IN REPLY REFER TO:
Case No.: 07-06-2364P
Follows Conditional
Case No.: 06-06-B748R
Community Name: City of El Paso, TX
Community No.: 480214
Effective Date of This Revision: NOV 3 0 2007

LETTER OF MAP REVISION
DETERMINATION DOCUMENT

ARROYO 4 - from approximately 80 feet downstream of Westwind Drive to approximately 130 feet upstream of Broadmoor Drive

THE PARK AT WILDWOOD

REVISED TO REFLECT LOMR EFFECTIVE NOV 30 2007

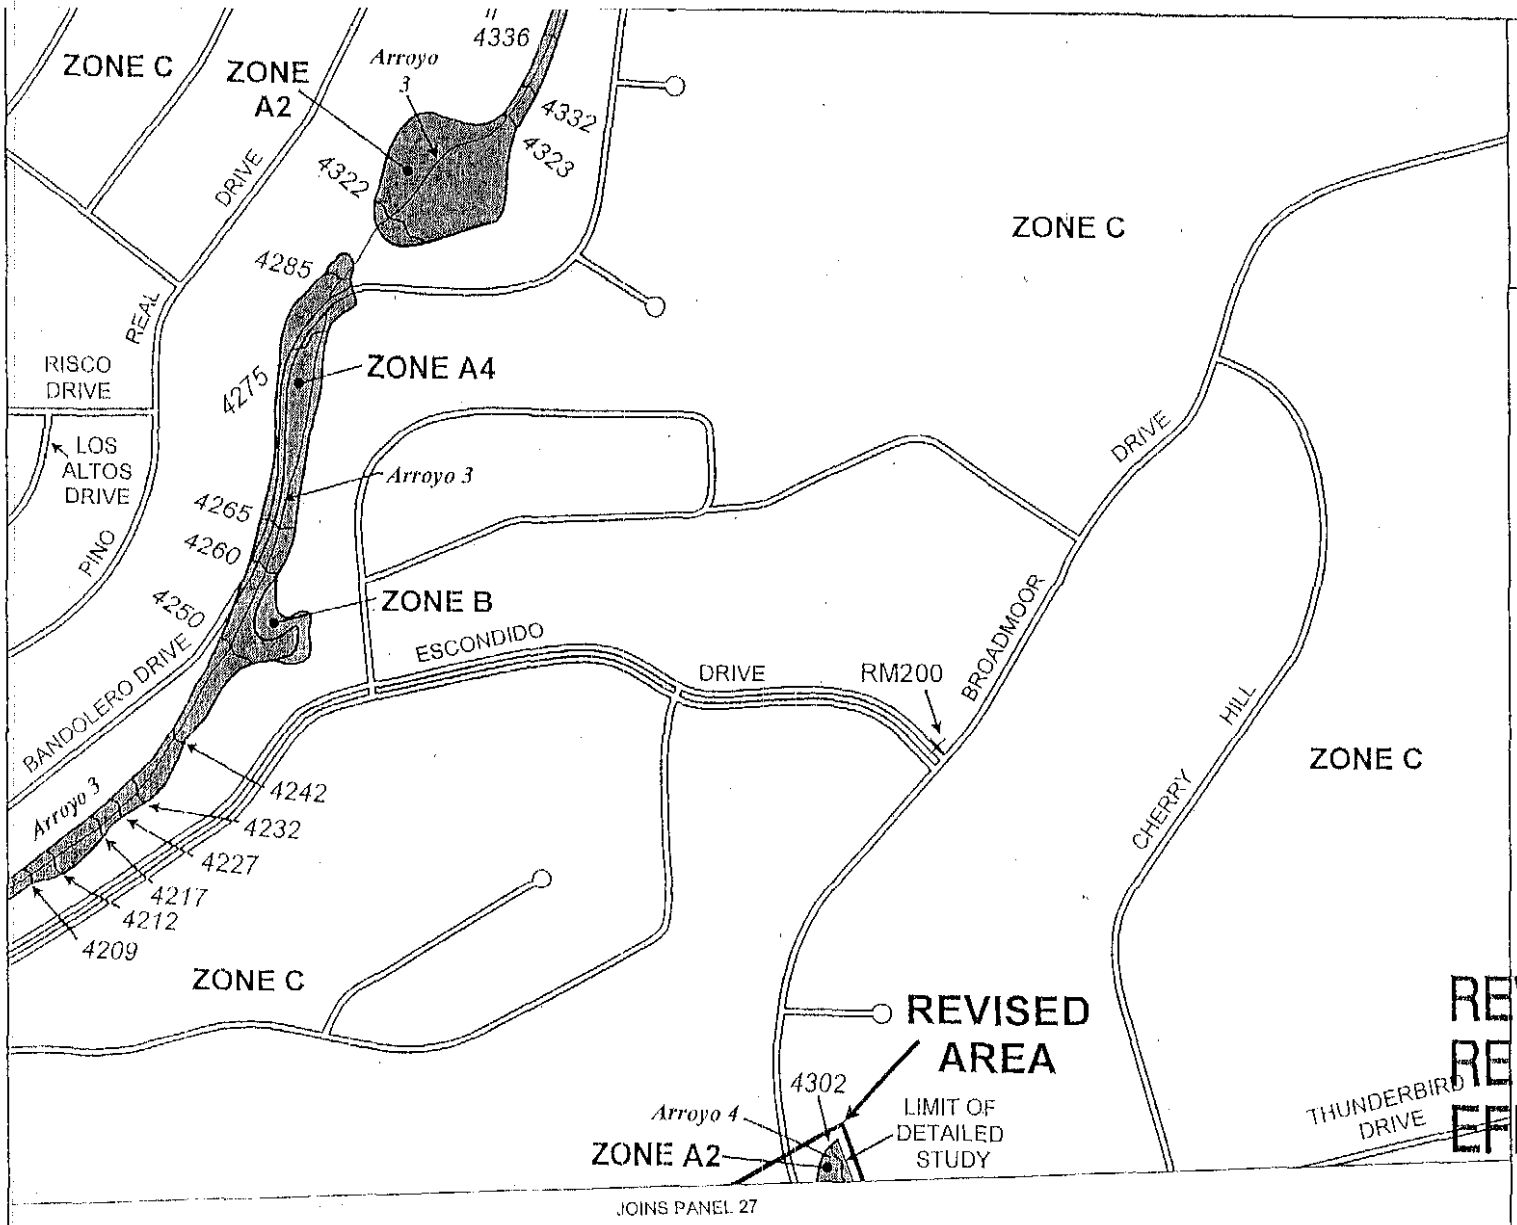
Flooding Source	Effective Flooding	Revised Flooding	Increases	Decreases
ARROYO 4	Zone A2	Zone A2	YES	YES
	BFEs*	BFEs*	NONE	YES

SUPPLEMENTARY INFORMATION: A hydraulic analysis was performed to incorporate new topographic information and the effects of placement of fill, channelization and culvert installation and has resulted in an increase in SFHA width, a decrease in SFHA width and decreased BFEs for Arroyo 4. The table below indicates existing and modified BFEs for selected locations along the affected lengths of the flooding source(s) cited above.

Source of Flooding	Location	Lat/Long Coordinates	Existing BFE	Modified BFE	Affected Communities
Arroyo 4					City of El Paso
	Approximately 50 feet upstream of Westwind Drive	31.50° 50' 25" / -106.31° 59' 18"	* 4148	* 4142	
	Approximately 120 feet upstream of Broadmoor Drive	31.50° 34' 40" / -106.31° 22' 87"	* 4305	* 4302
